New Albany Planning Commission Agenda
Monday, July 15, 2024 at 7:00 p.m.

Re: McDonald's FDP

PROPOSED MCDONALD'S RESTAURANT AT:
1955 BEECH ROAD
NEW ALBANY, LICKING COUNTY, OHIO

August 2023 (Figure 1)

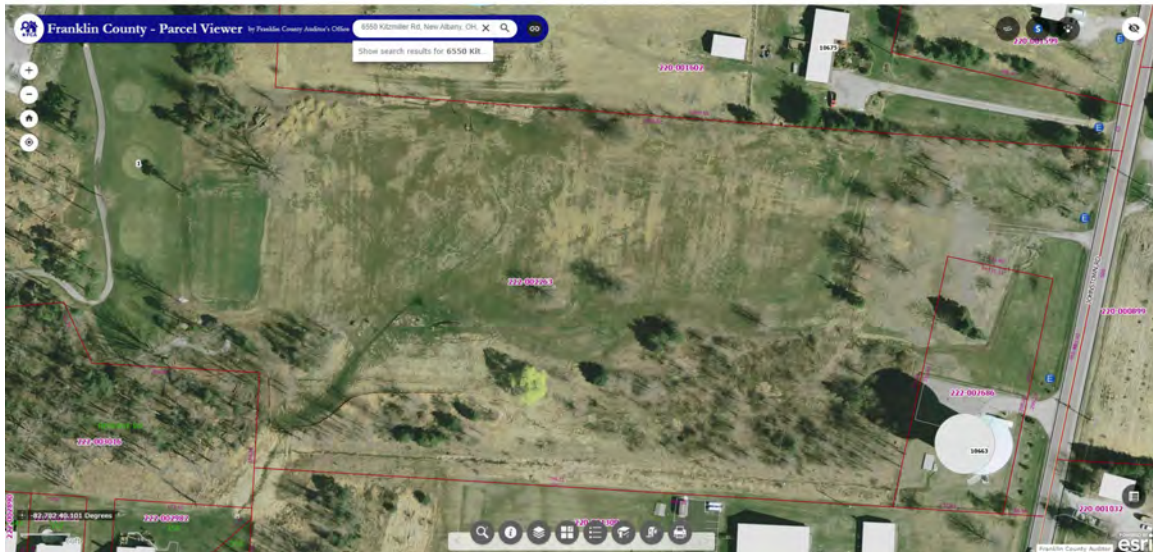
1. In early November, a neighbor reported to the city staff that golf balls were appearing in the side and rear of their property. During a code enforcement inspection, city staff found that the landscape on the property had been removed. Because there were significant changes to the approved final development plans from 2009, it needs to be re-evaluated by the Planning Commission.

Planting Plan

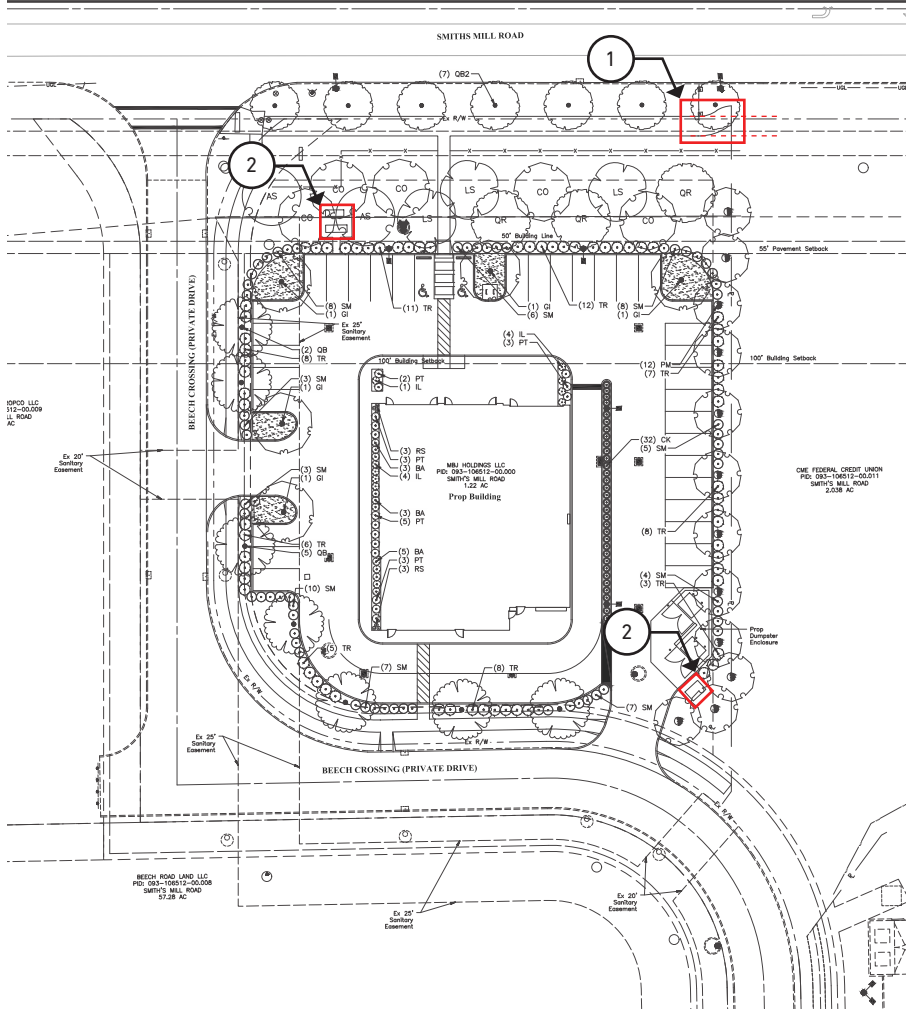
2. Provide evergreen shrubs (36" in ht.) to screen utilities, as marked. See diagram.

Site Plan

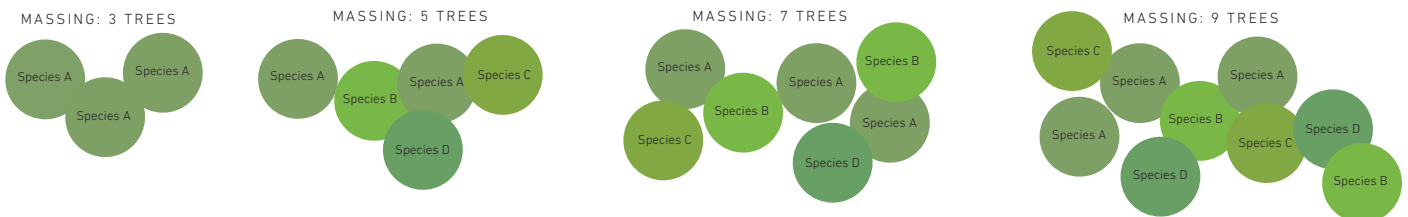
1. Realign the access drive adjacent Johnstown Road to create a consistent transition from the existing drive at the neighboring parcel. See diagram.
2. Realign the proposed parking to follow the building and pavement setback with the shifted access drive, and accommodate parking requirements. See diagram.
3. Realign proposed pedestrian connection from Johnstown Road to safely connect across the recommended access drive. See diagram.
4. Provide a pavement marking plan for review of vehicular circulation at access drives and drive through lanes. Resubmit plans. See diagram.

JOB NO. 23-0187
DATE: 04-17-24
SCALE: 1"=20'
SITE PLAN
SHEET: C3.0

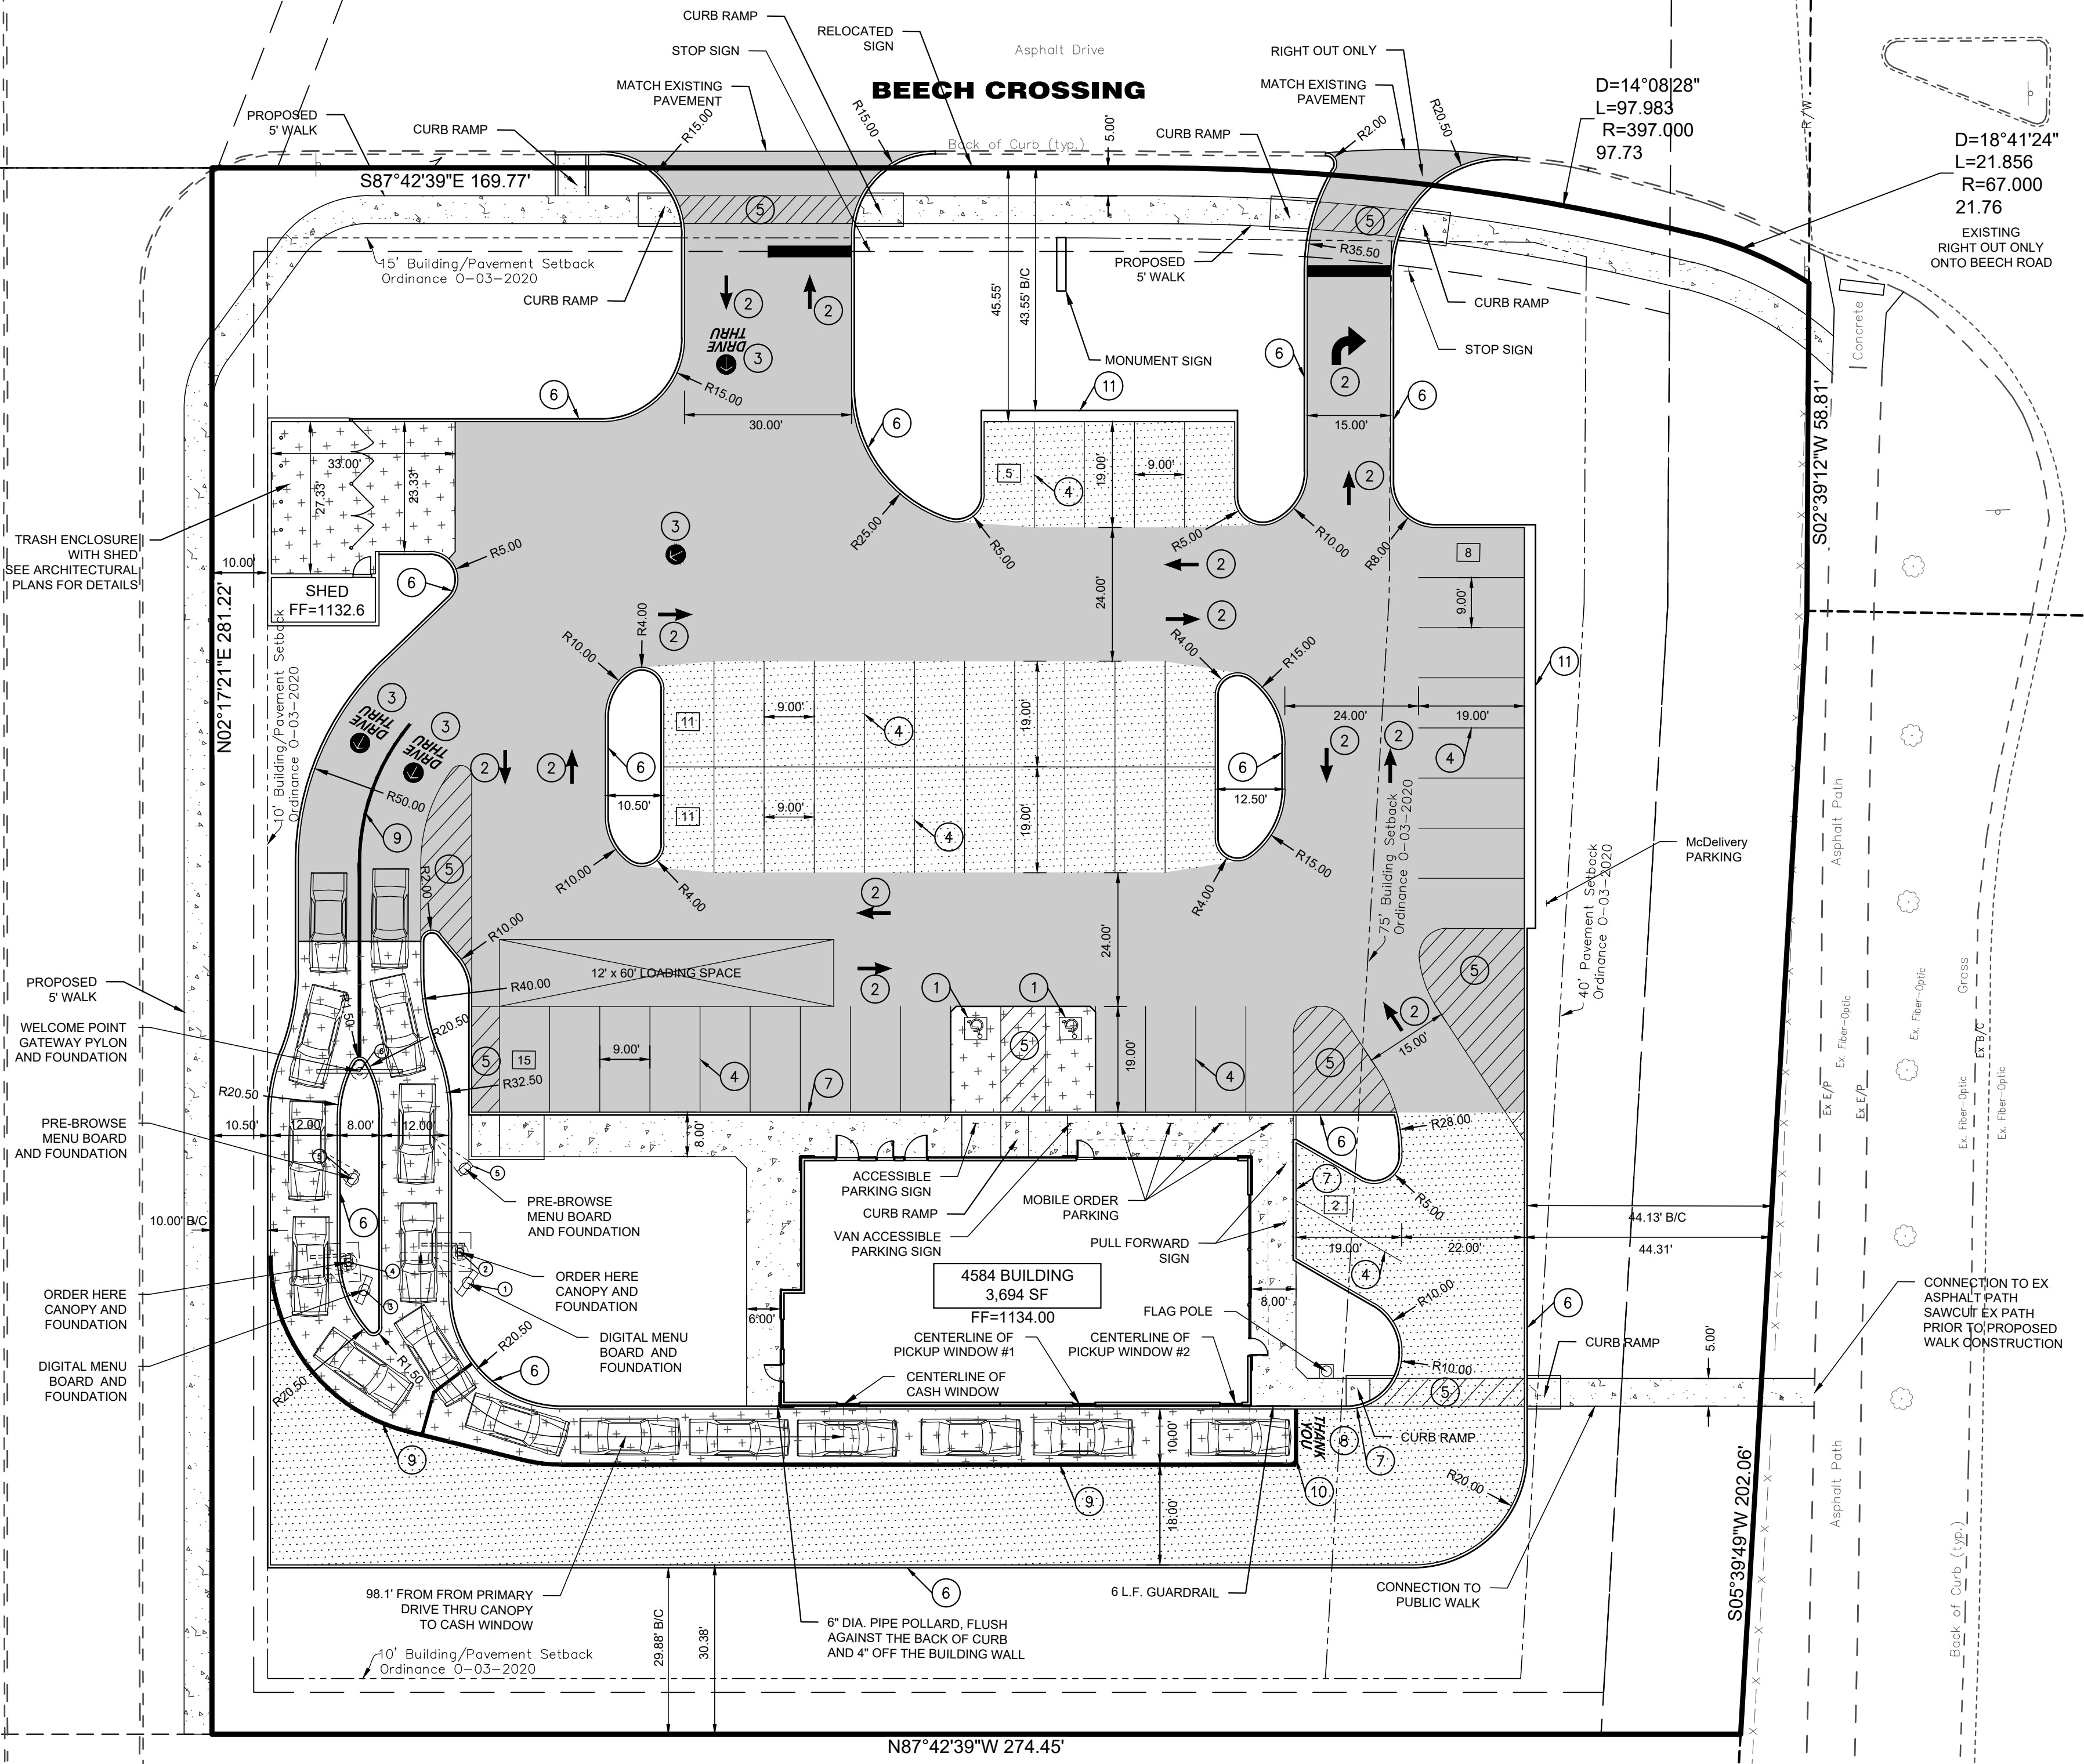
2. Sheet C3.0: Add stop signs/stop bars at the curb cuts.
3. Sheet C3.2: Note that the City requires detectable domes to be red clay brick.
4. Sheet C4.0: Add notes requiring that the water service beneath Beech Road be constructed using Horizontal Directional Drilling. Open cut of pavement is not permitted.

JOB NO. 23-0187
DATE: 04-17-24
SCALE: N.T.S.
EROSION CONTROL NOTES
SHEET: C6.1

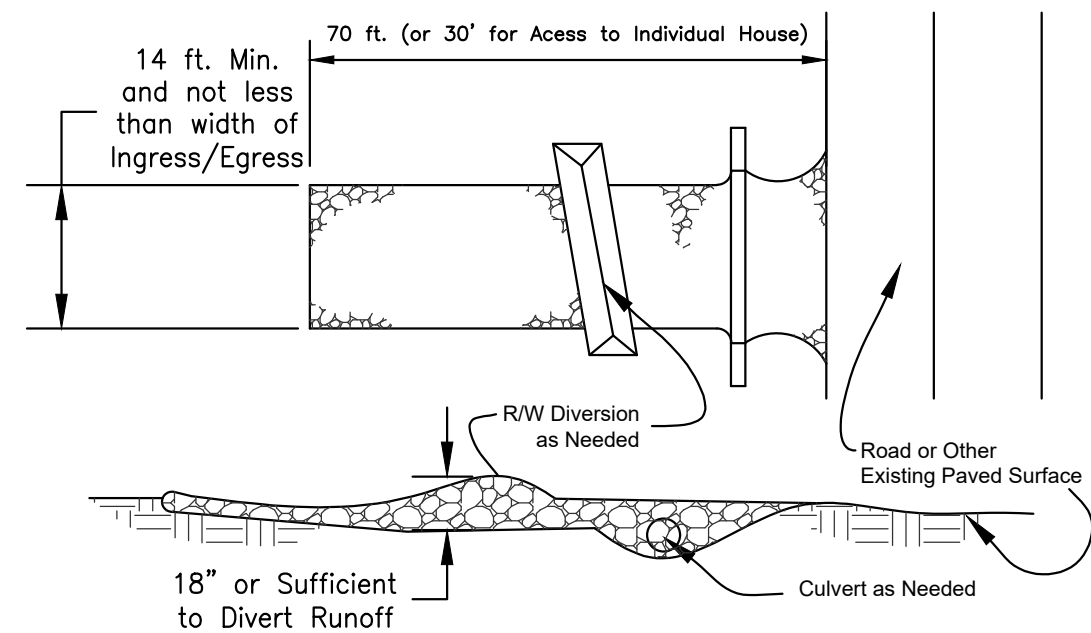
5. Sheet C5.0: Add a legend that includes a major flood routing arrow and show major flood routing in plan view.
6. Sheet C6.1: Revise note 2 at the bottom of this sheet by deleting 21 days and adding back 14 days.

JOB NO. 23-0187
DATE: 03-08-24
SCALE: 1"=20'
PLANTING PLAN
SHEET: L1.0

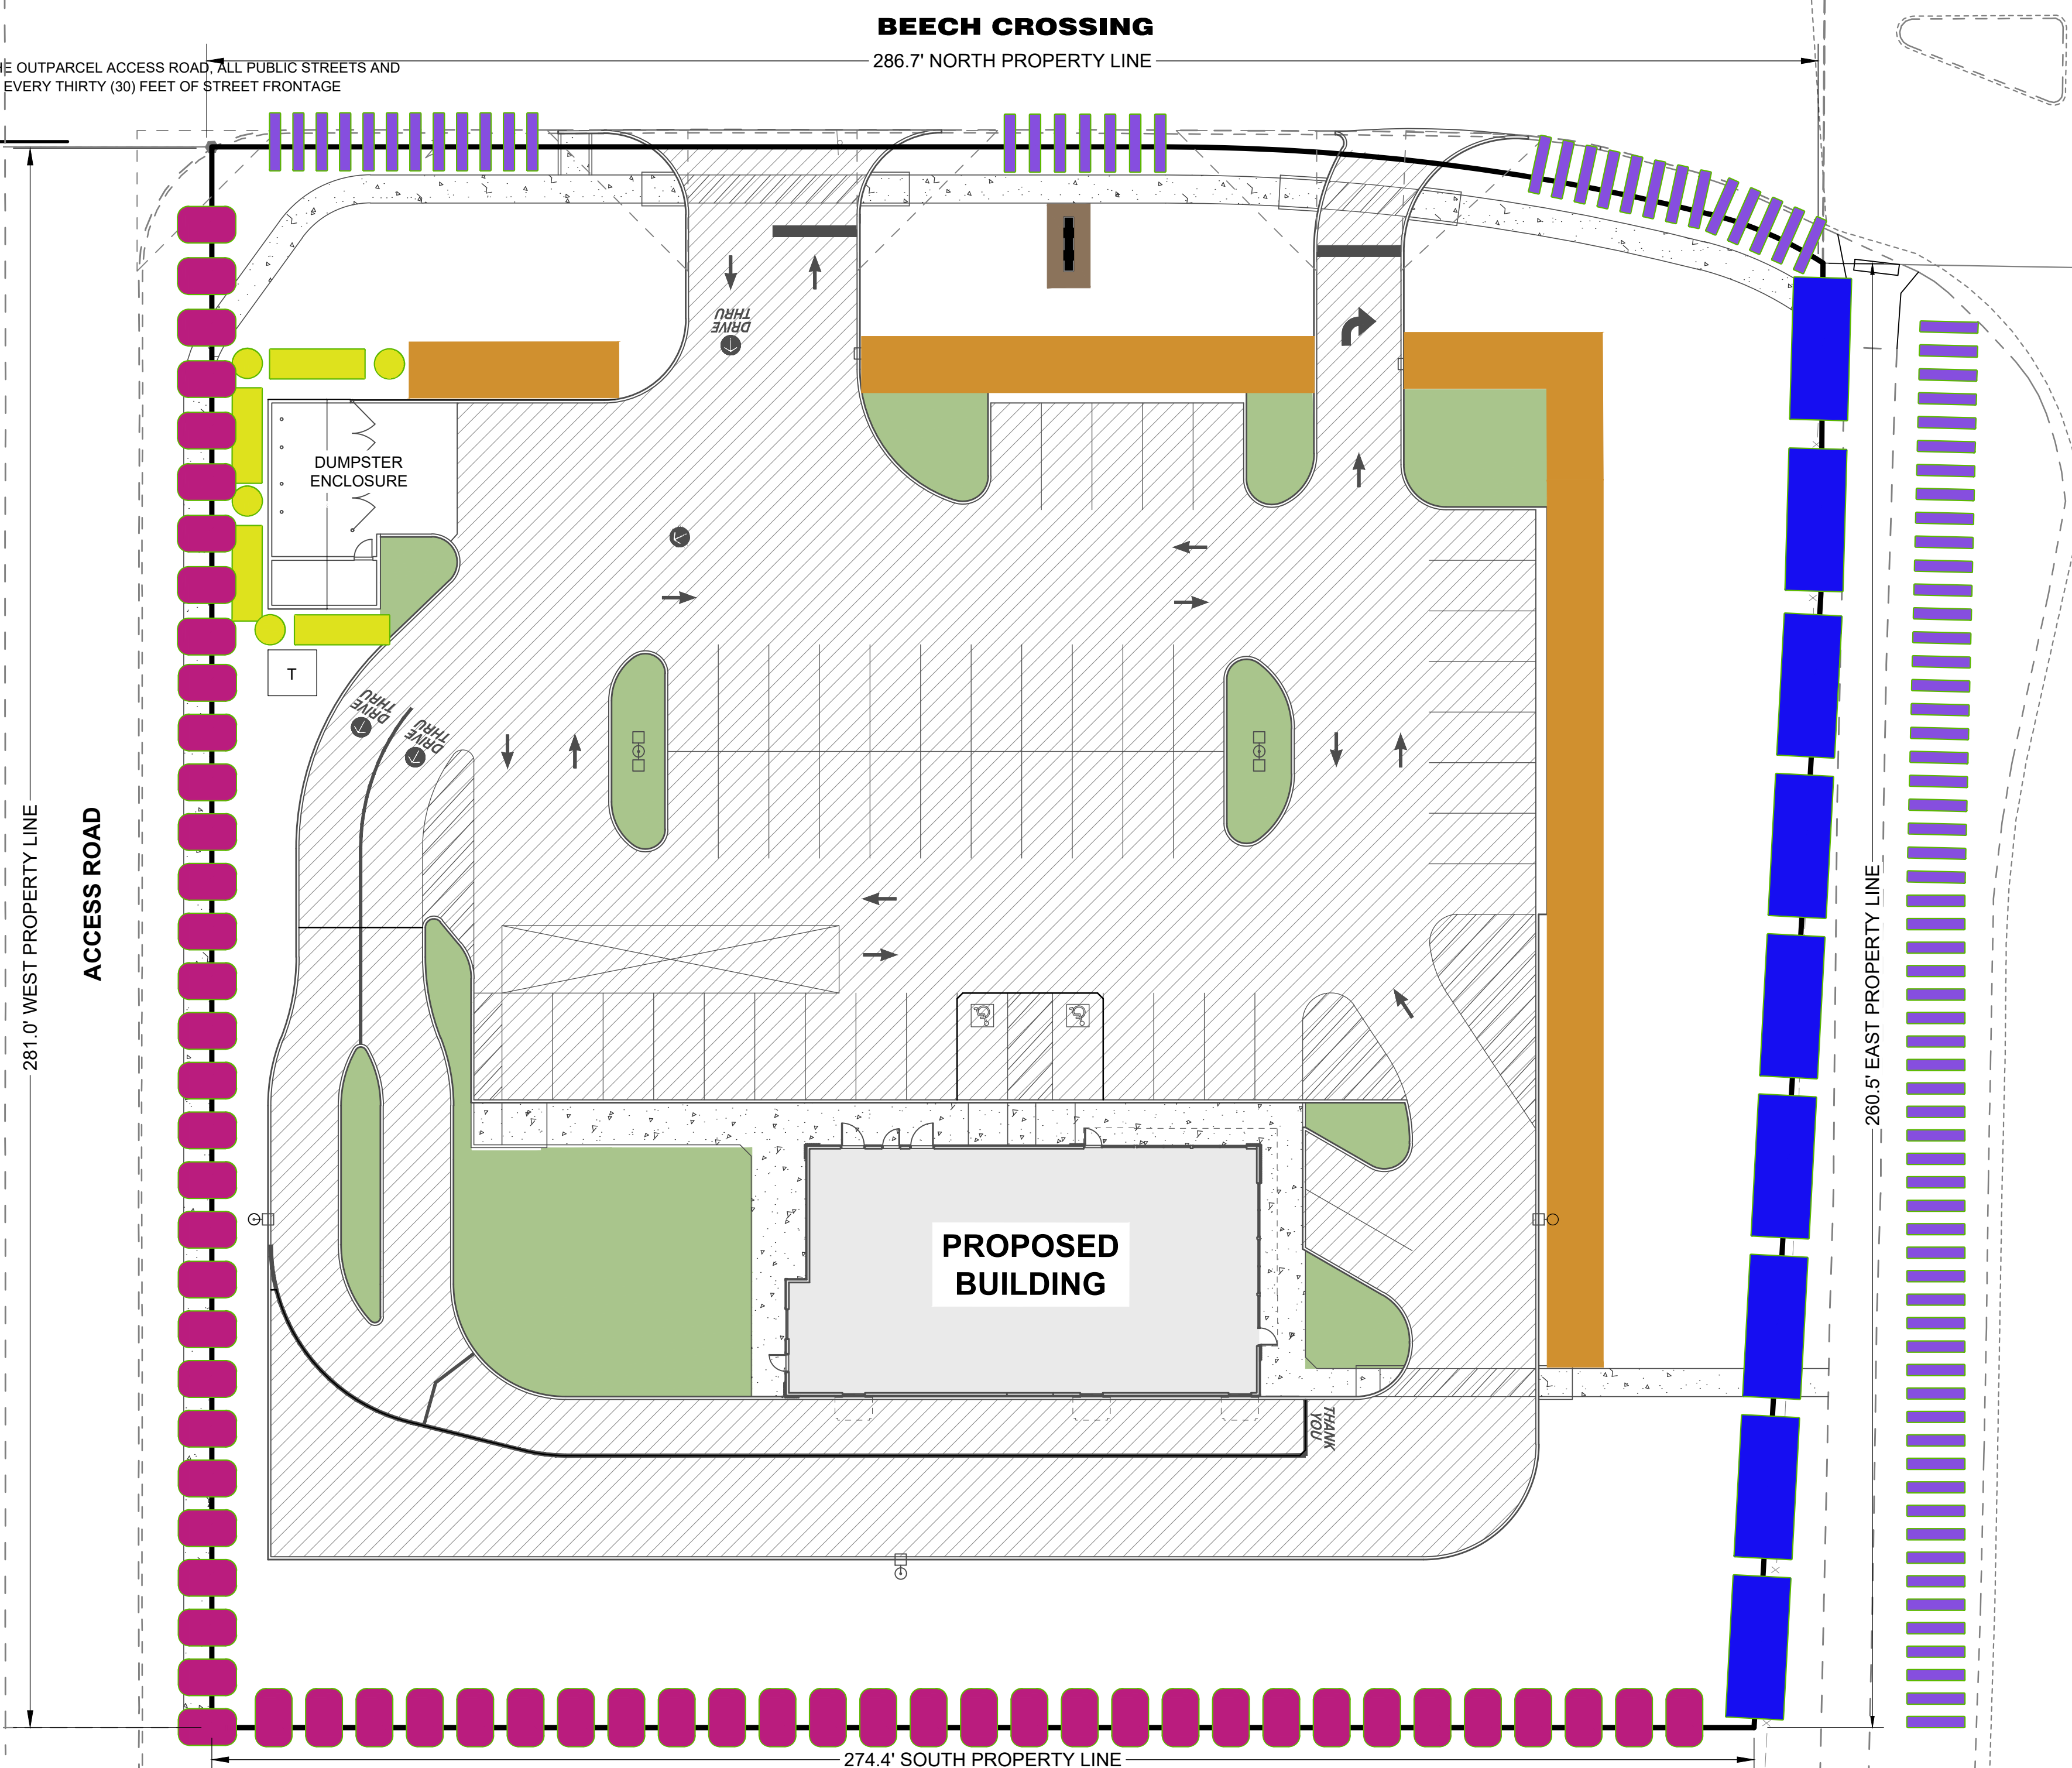
7. Sheet C6.1: The City recently updated the seed application rate to be 14 lbs. per 1000 SF, City of Columbus Type 1 Lawn Mix.
8. Sheet L1.0: Add site distance triangles at the cuts and remove landscaping that impedes motorist view.
